CALLISON

April 12, 2012

Re: Chase – Cedar Oak & Willamette, 19080 Willamette Drive, West Linn, OR
210461.89
Class II Design Review Application (DR-12-08 et al) – Completeness Review Response

LANDSCAPE PLAN

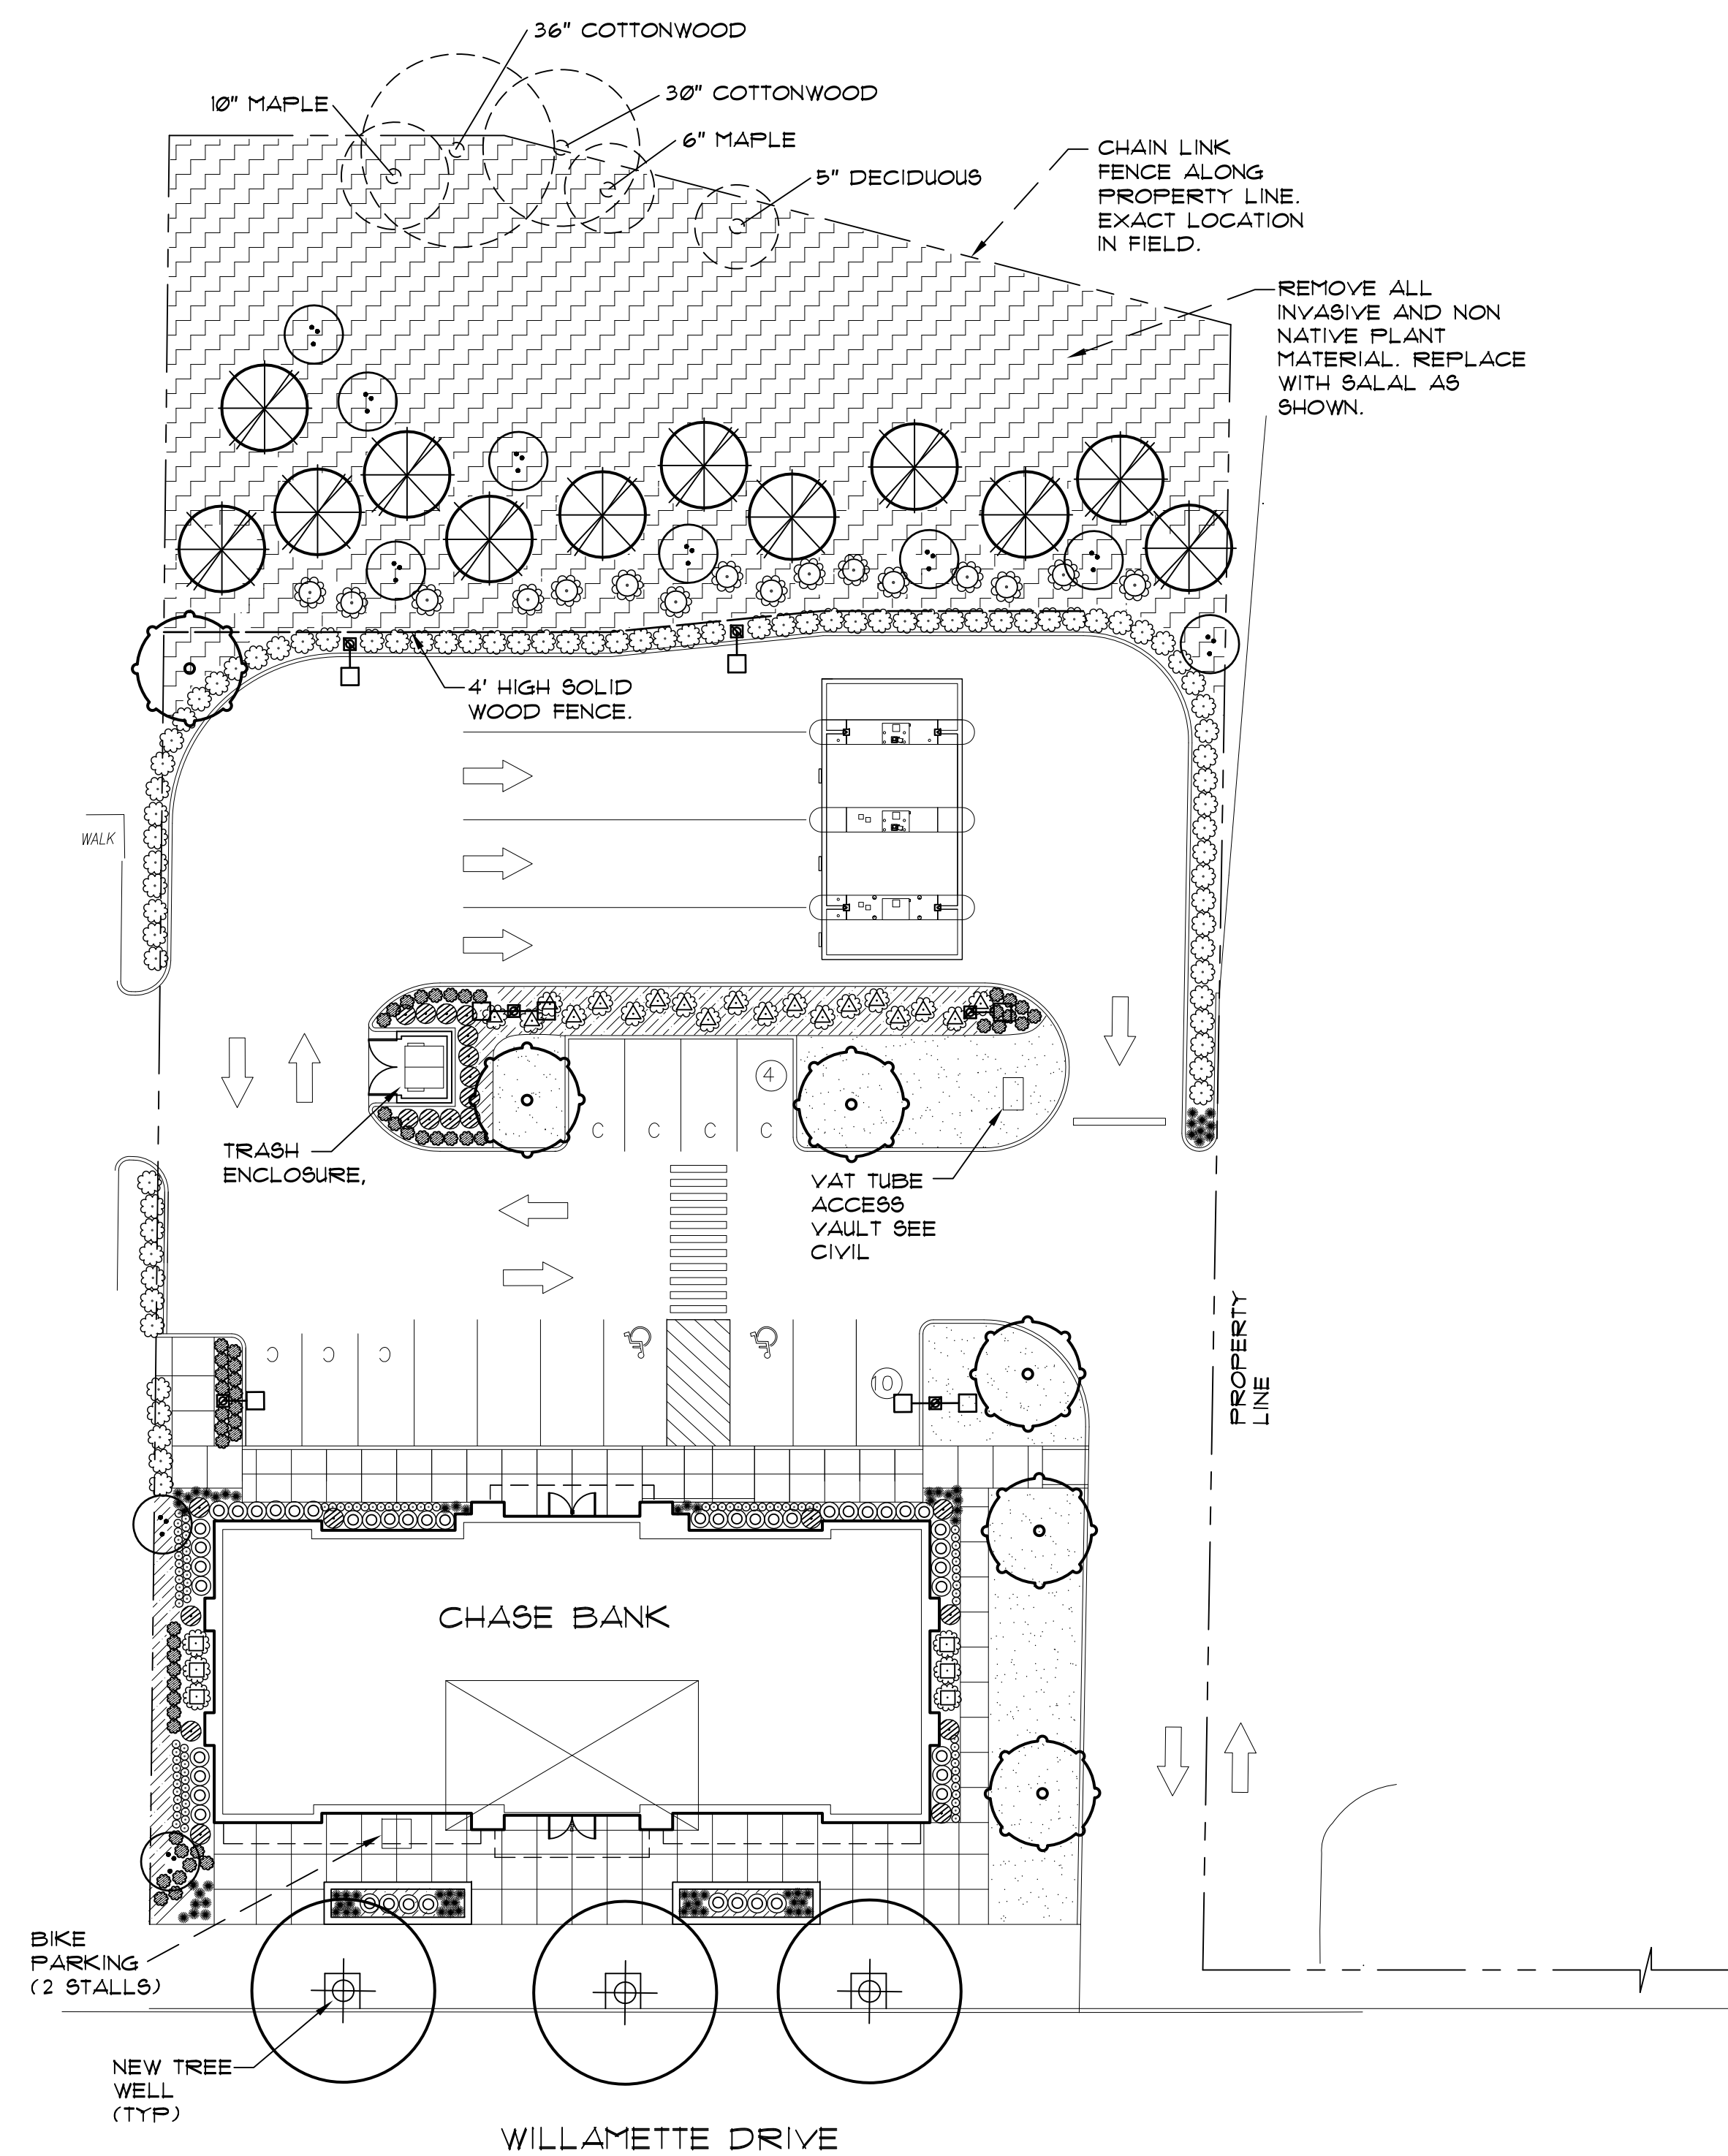
Chapter 54: Landscaping. Discuss plans to remove non-native plant/invasives at the rear of the property and replace with approved natives or allowed alternative material.

A note has been added to the Landscape plan regarding the non-native plant/invasive at the rear of the site. The note states the following:

“Remove all invasive and non-native plant material. Replace with Salal as shown.”

SITE PHOTOMETRIC PLAN
SCALE: 1"=10'-0"

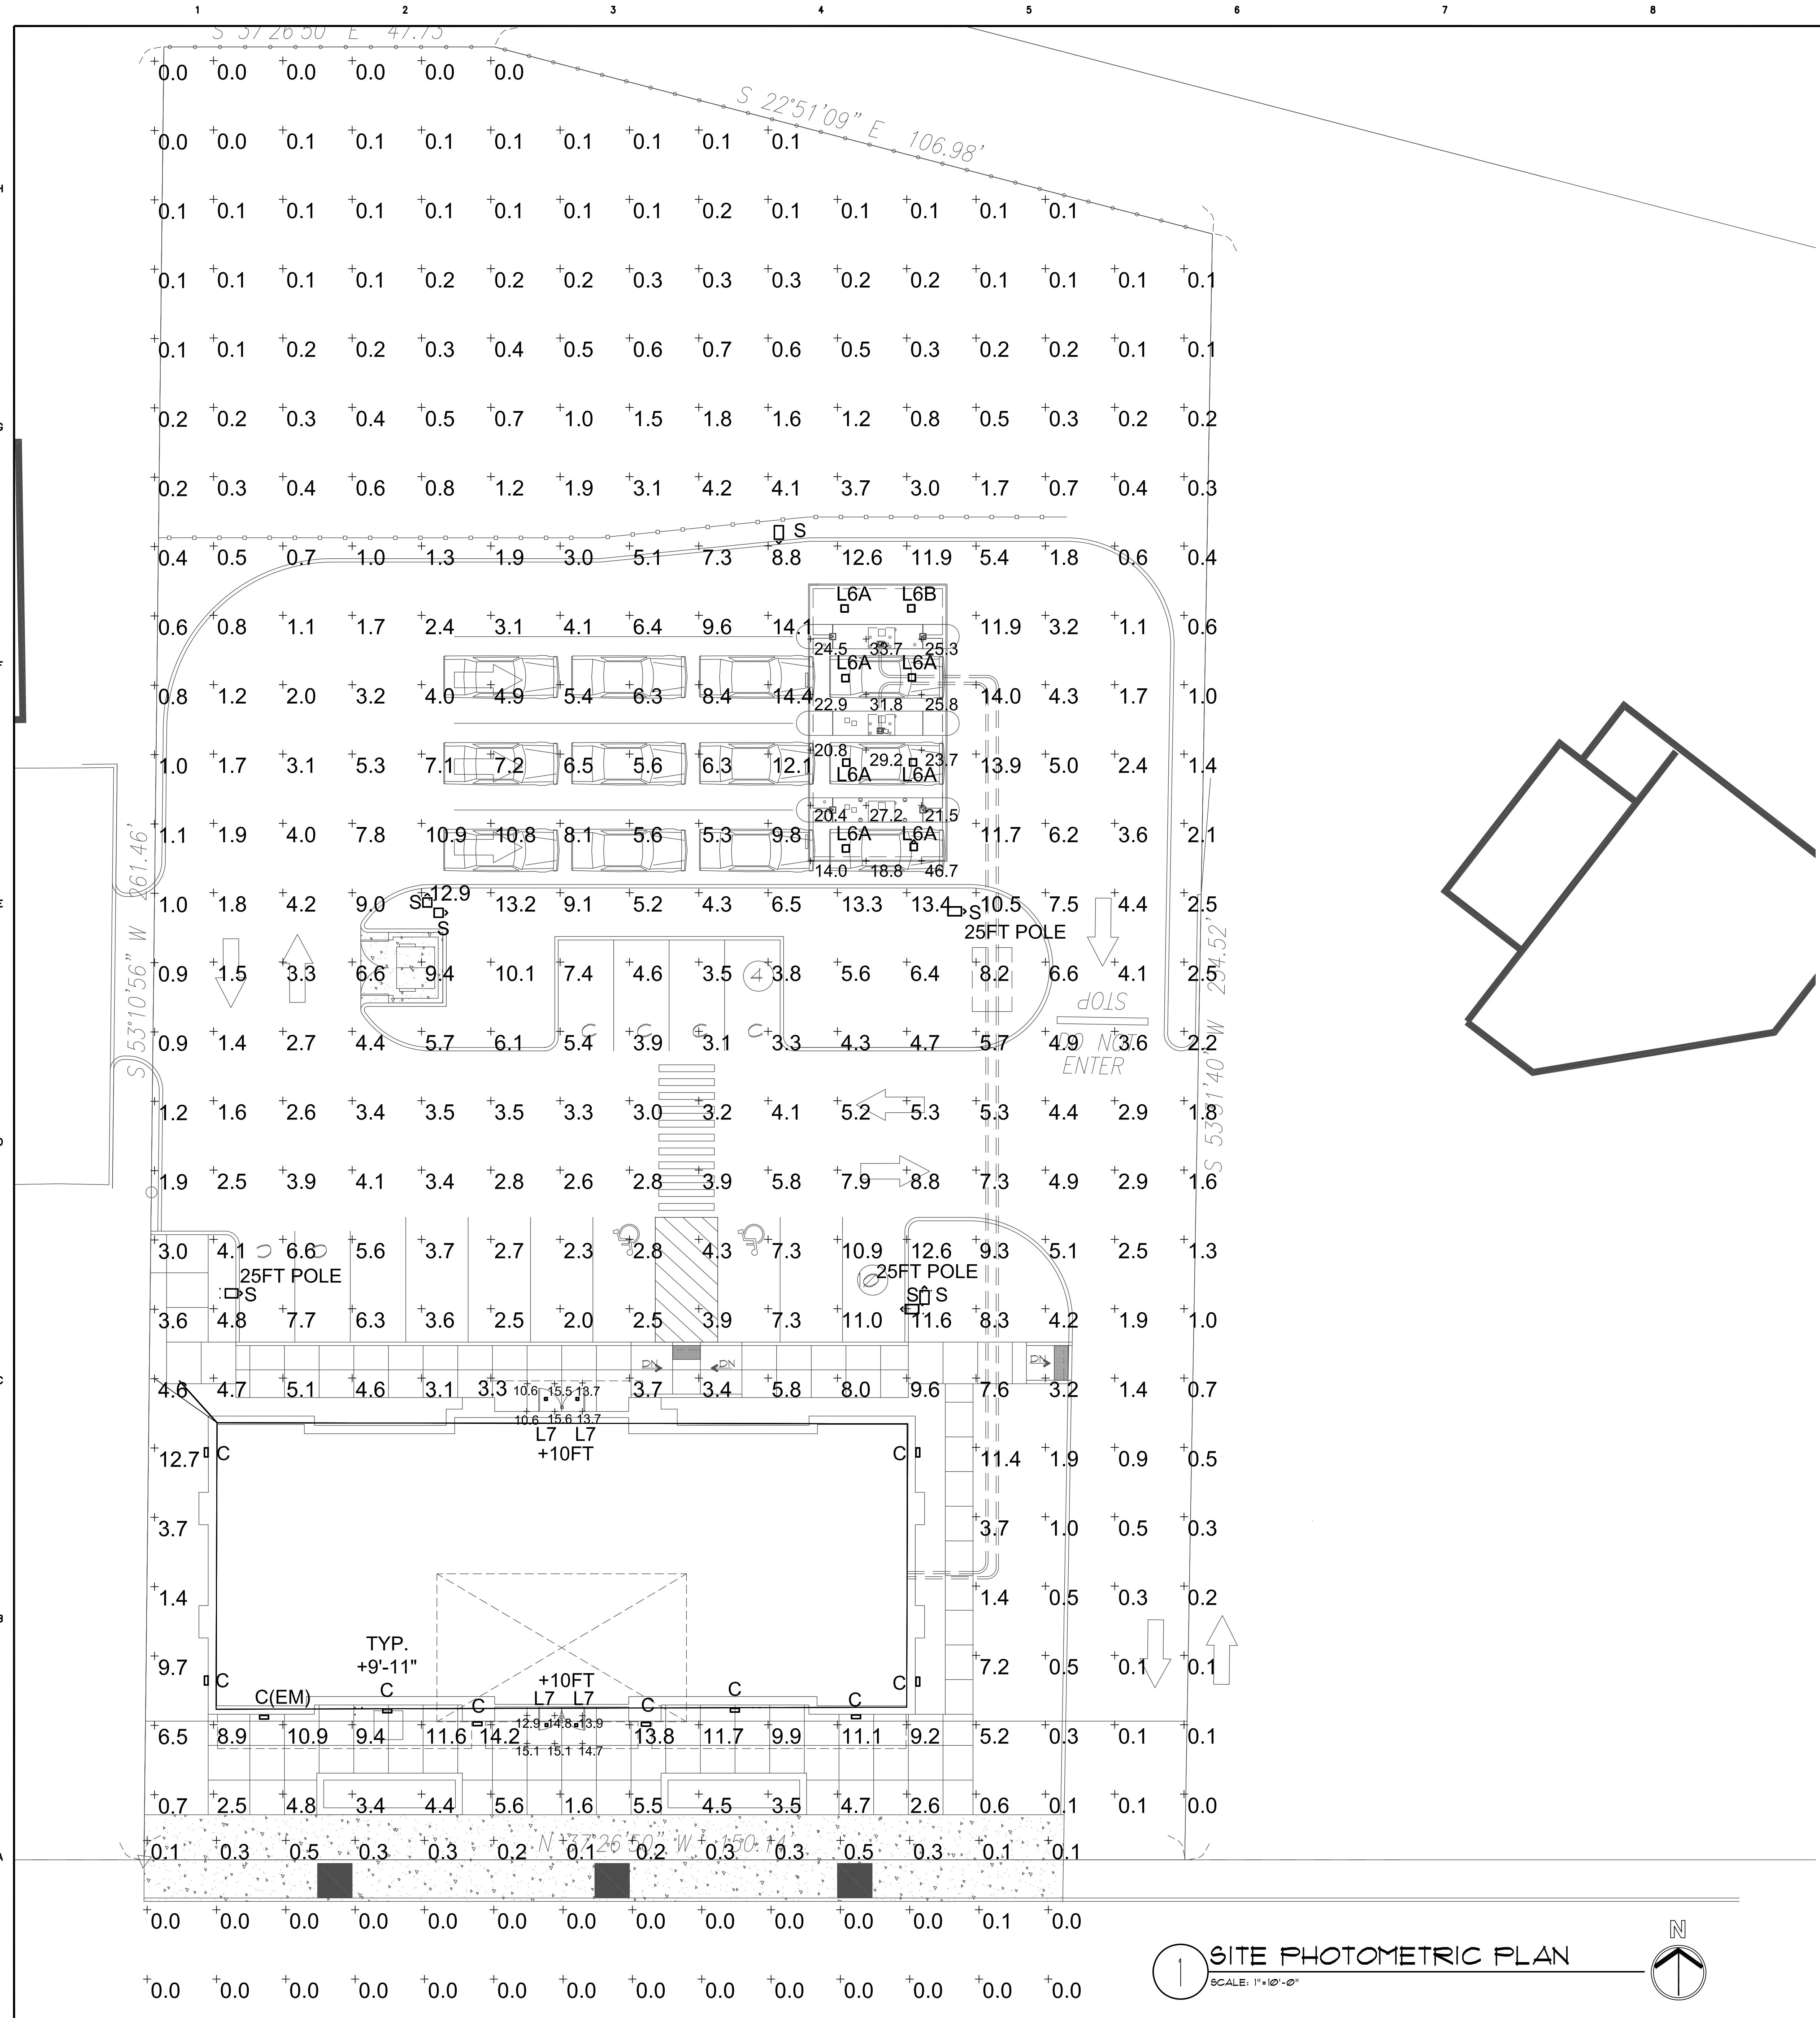
*55.100(J) (6) The lighting plan shows metal halide fixtures. Low or high pressure sodium fixtures are required per the CDC. The City will consider LED lighting substitution. All fixtures must be physically shielded especially from the housing to the east.

Parking light lighting poles been updated to Low Pressure Sodium. LED lighting fixtures are proposed for the under canopy lighting for the drive-thru canopy. Compact Fluorescent Light (CFL) fixtures are proposed for building mounted site lighting.
